SPECIFIC REQUIREMENT'S (Section- Project)
C/ENGG/SPEC/SEC-PROJECT/SPECIFIC REQUIREMENT REV NO 02

Employer has standardized its Specific Requirement for various equipments and works for different voltage levels. Items or clauses, which are not applicable for the scope of this package as per schedule of quantities described in BPS or as per scope defined elsewhere in Section Project, the technical specification/clauses for the items specified below should not be referred to.

DRAWING NO. C/ENGG/SS/CONCEPTUAL 765KV BAY CONNECTIONS
REV.0 SH.10F1

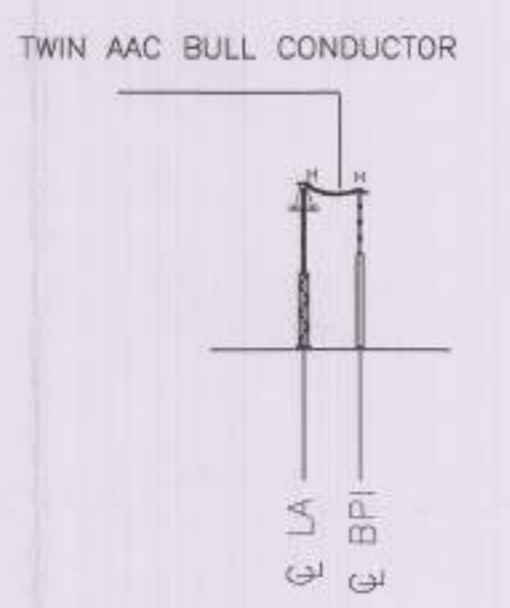
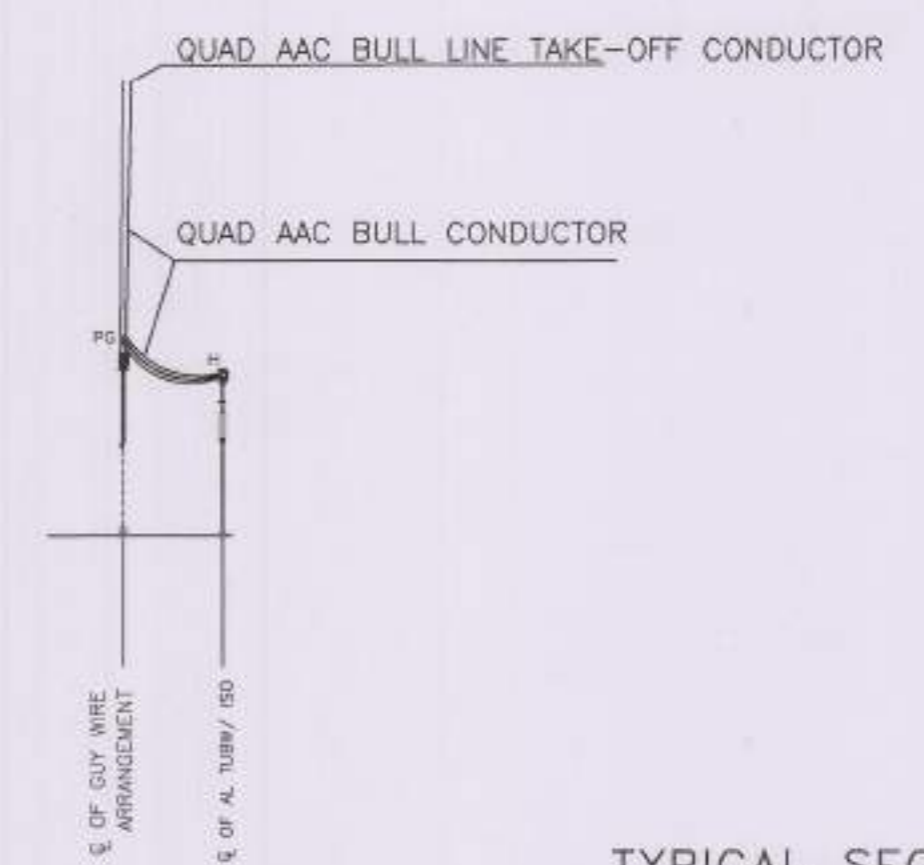
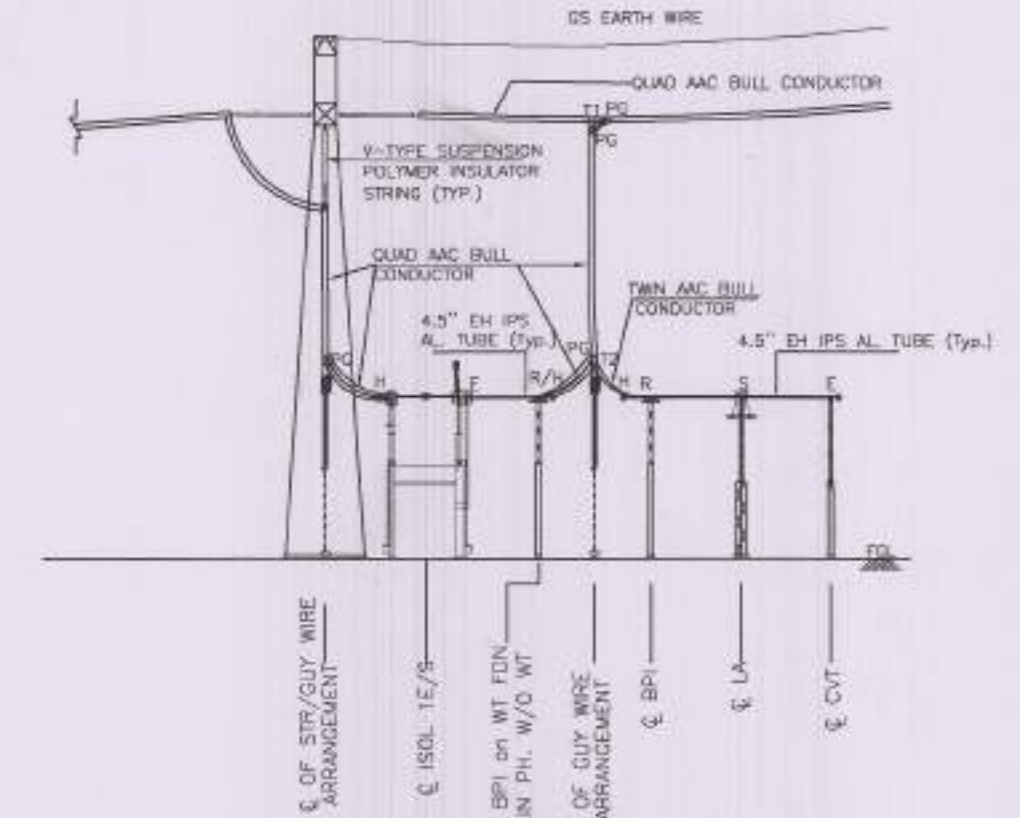
67.	Section Switchyard Erection Rev 10 New Clause No. 21	Connection arrangement of 765kV equipment's shall be done as per the conceptual drawing (Drawing No. C/ENGG/SS/CONCEPTUAL 765KV BAY CONNECTION, Rev-0) enclosed as Annexure-S1of this Section-Project.
